**ASSESSMENT OF AFS STRUCTURAL WALL SYSTEM**  
**FOR**  
**CBPA NSW, FEBRUARY 2008**

The intent of this assessment is to identify any weaknesses or possible shortcomings of the AFS wall system.

## DETAIL #1

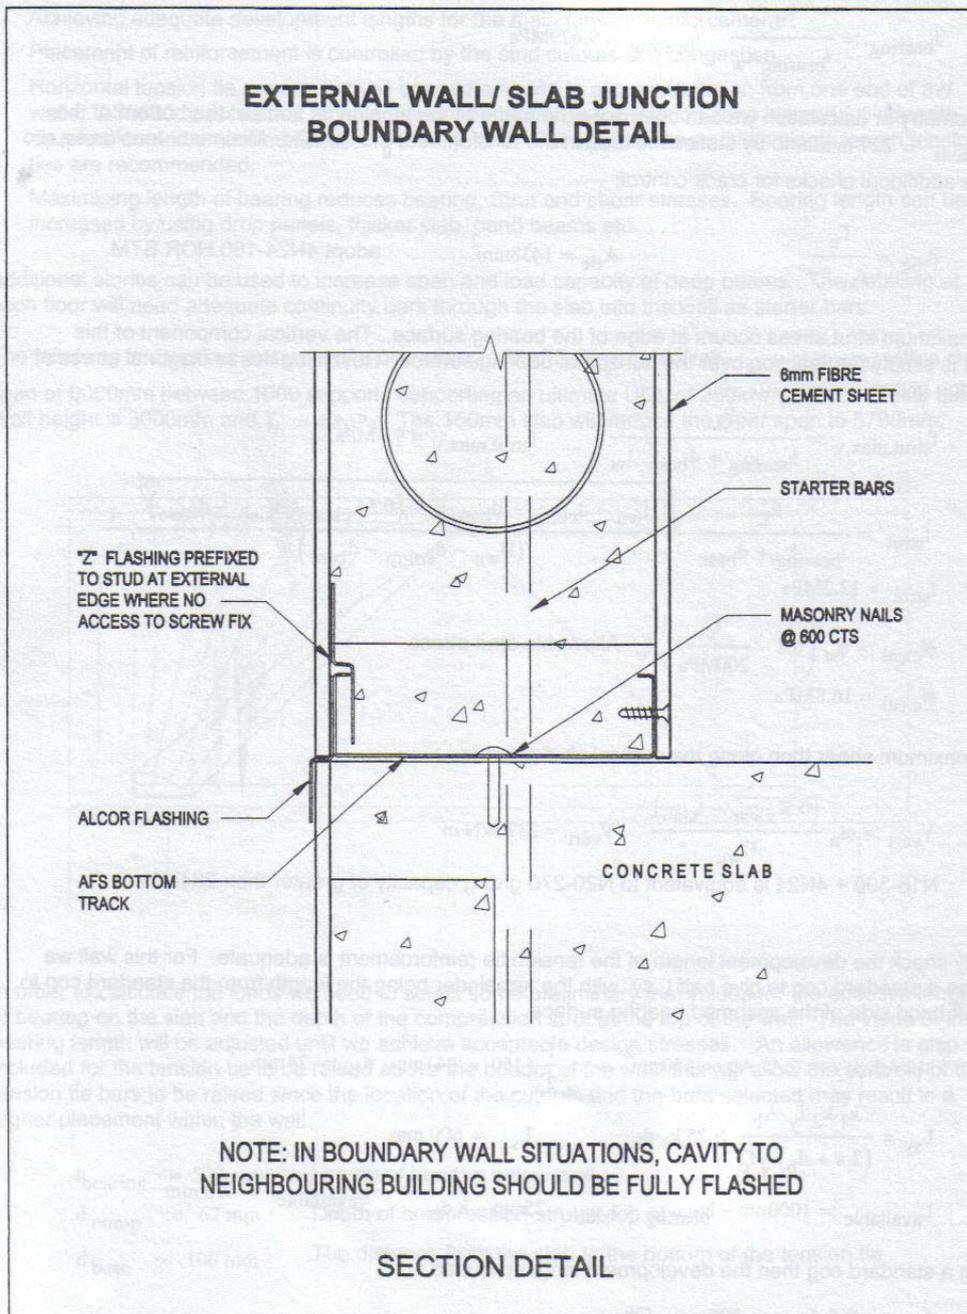
This shows that the system is intended to be used as a single skin wall in external applications. Therefore, the system totally depends on the effectiveness and integrity of the waterproofing coating and the flashing (in the drawing above it is shown as Alcor) to prevent moisture from reaching the inside face. There is no cavity to trap moisture before it reaches the inside face.

If the waterproof coating is damaged in any way, or if there is any relative movement between other building elements, or if there is any relative movement between the AFS panels that are joined at 1200mm intervals by a plastic panel joiner strip, there is the potential for moisture to travel straight through the wall. Whilst the AFS Structural Wall Technical Manual probably quite rightly claims this is a failure of the waterproofing system that does not help the client that has moisture coming through to the inside face. It may not be a failure of the AFS system itself but it would be a failure of the wall. The fact that a possible failure of the waterproofing system is even discussed in the AFS Structural Wall Technical Manual suggests that it is a scenario they consider may occur.

Chart 4.  
Structural Adequacy FRP (minutes) for 150 mm Clay Masonry Walls with Simple Supports on Four Sides

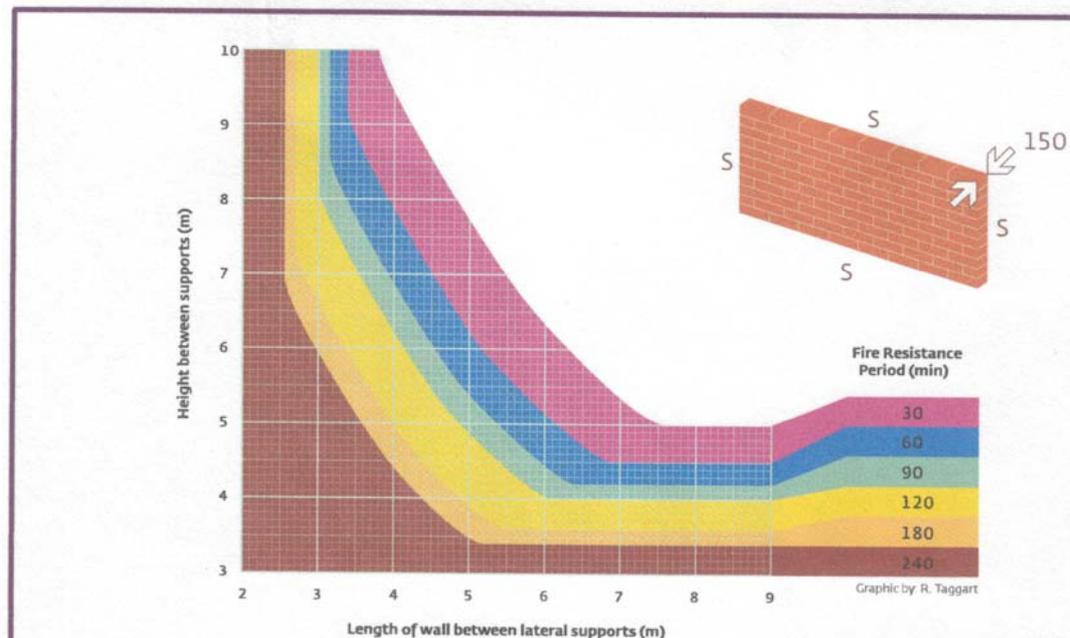
This is compared to the chart for a 150mm thick clay brick wall taken from the Think Brick Australia document Design of Clay Masonry Walls for Fire Resistance which shows the variation in structural adequacy with length and height.
